# Value Planning Report

## Plan Formulation Project South Utah & Juab County, UT

Workshop Dates: June 24-28, 2024  
Report Date: October 29, 2024

Final  
Value Engineering Study Report  
for

Alternative No.: PW-19

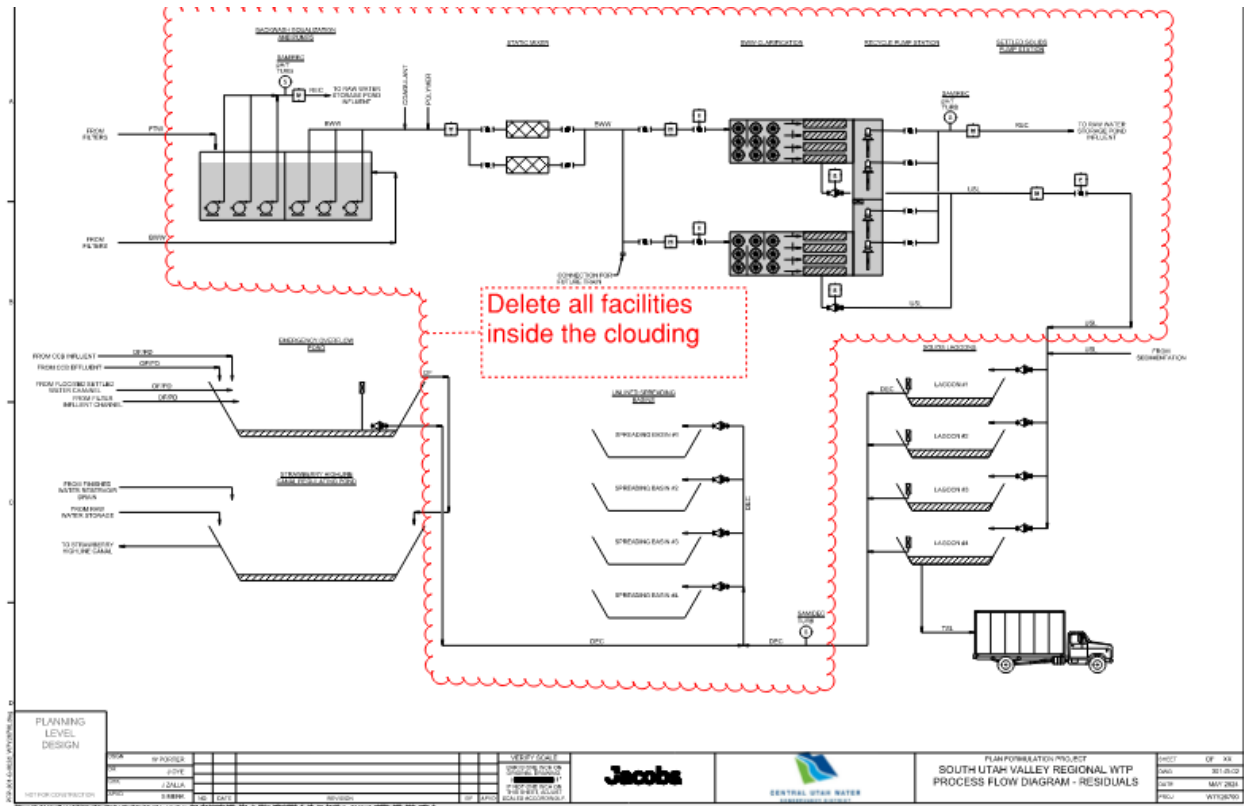
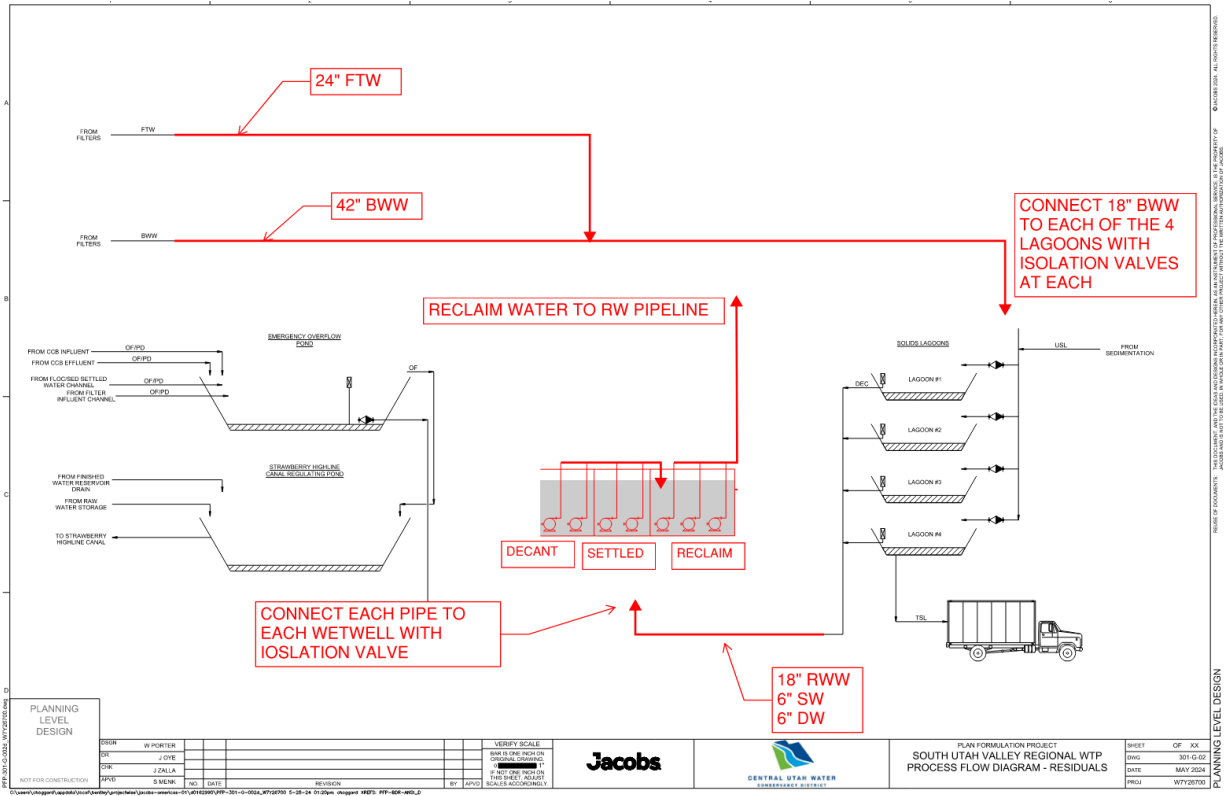
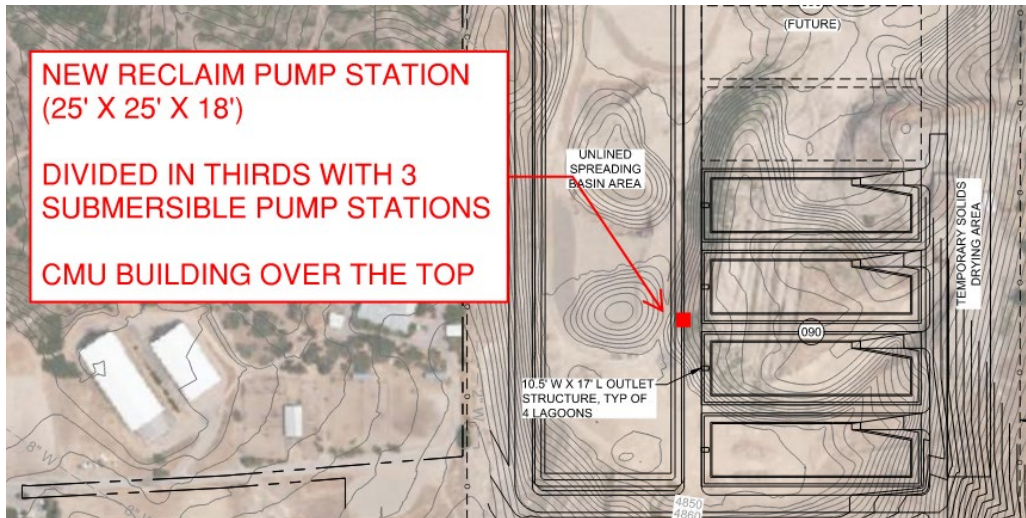
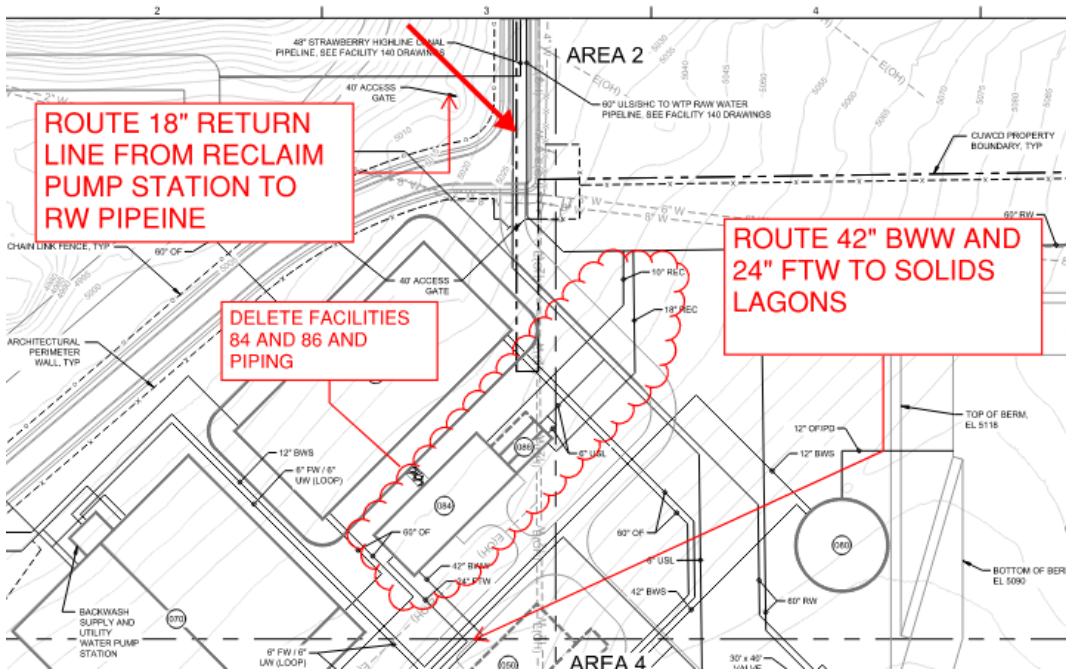
This exact process has been implemented at the District's Duchesne Valley WTP, and very similar processes have been implemented at Point of the Mountain WTP (Metropolitan Water District of Salt Lake and Sandy) and Weber South WTP (Weber Basin Water Conservancy District).
